## SERVICE BULLETIN

**Ref: SRV-17-002**

**Product: AirFlex**

**Re: Divider Lock Assembly**

Figure 1

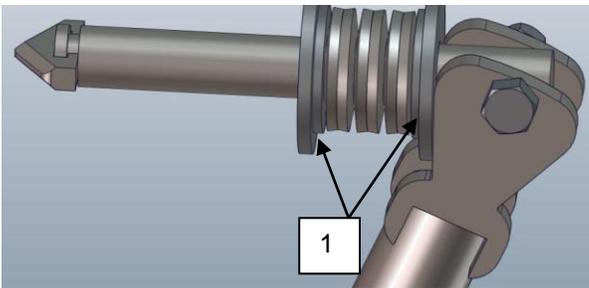
**Problem:** The dividers will fall off the end sheet or will become loose causing calibration issues by allowing the divider to move with the sensor.

**Solution:** The spring washers on the over center latch will become loose. The divider will not be held to the end sheet and can cause the latch to turn and allow the divider to fall off. In order to resolve the issue the spring washer arrangement has been changed. The number of the Belleville washers has been increased. This will increase the tension on the latch and hold the divider to the end sheet.

The two flat washers on the end of the latch, item 1 Figure 1 Part number 19940, are removed. Install two Belleville washers, Part number 26571, in their place as shown in Figure 2. The washers should be installed in pairs with the cupped side toward each other as shown.

If the customer is not going to take the divider off during transport the entire latch assembly can be removed and a 5/8"X4" bolt, nut and two flat washers can be used in the place of the latch.
